**CALIFORNIA
BUILDING
STANDARDS
COMMISSION**

**MONOGRAPH
of
PUBLIC COMMENTS**

2004 ANNUAL CODE ADOPTION CYCLE

October 2005

FIGURE 11B-2A—ROLL-IN SHOWER

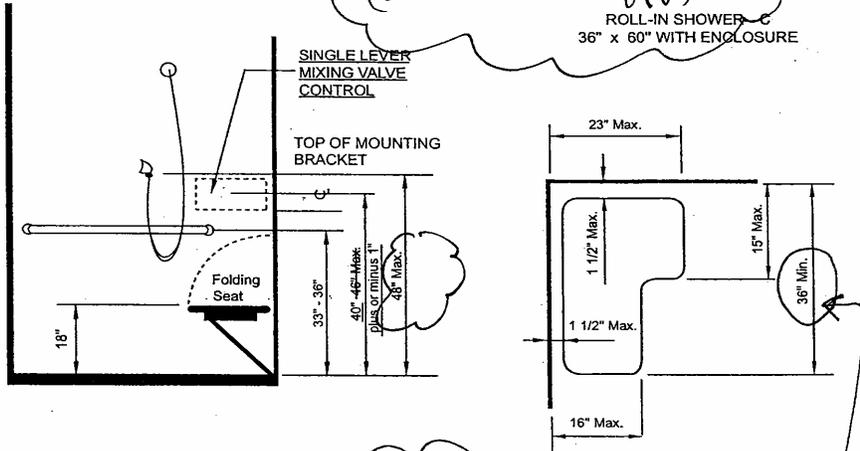
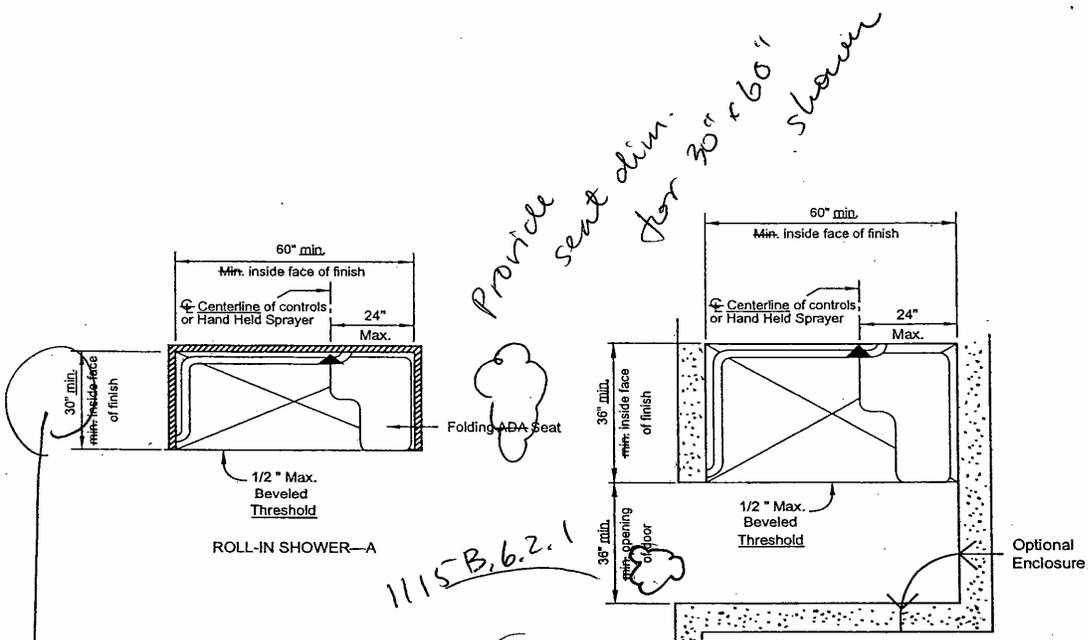
Provide seat dim. for 30" x 60" shower

(or) instead of (PLAN)
ROLL-IN SHOWER C
36" x 60" WITH ENCLOSURE

7 these dimensions don't match. Should

FIGURE 11B-9A

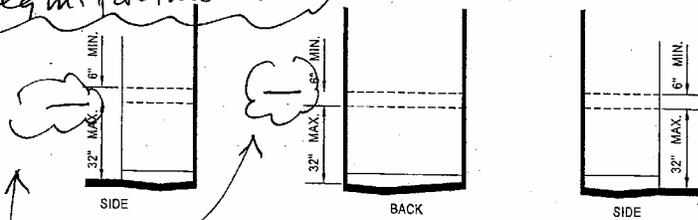
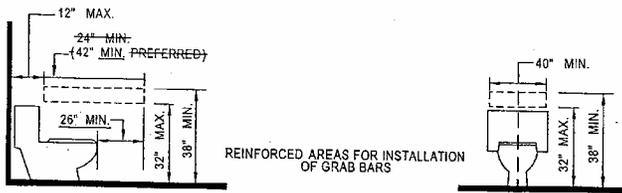
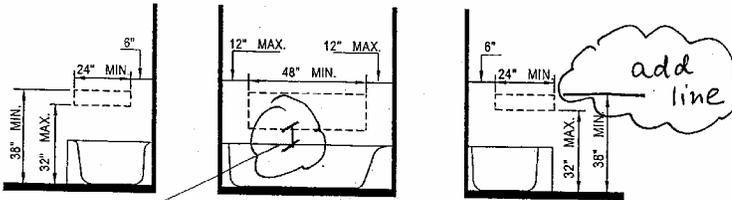
Is there a req't for this dim?

FIGURE 11B-9B—GRAB BARS AT BATHTUBS

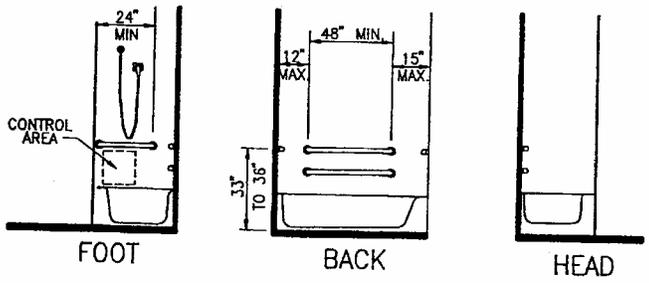
See attached amendments to figures. (Conflicts with the ADA)
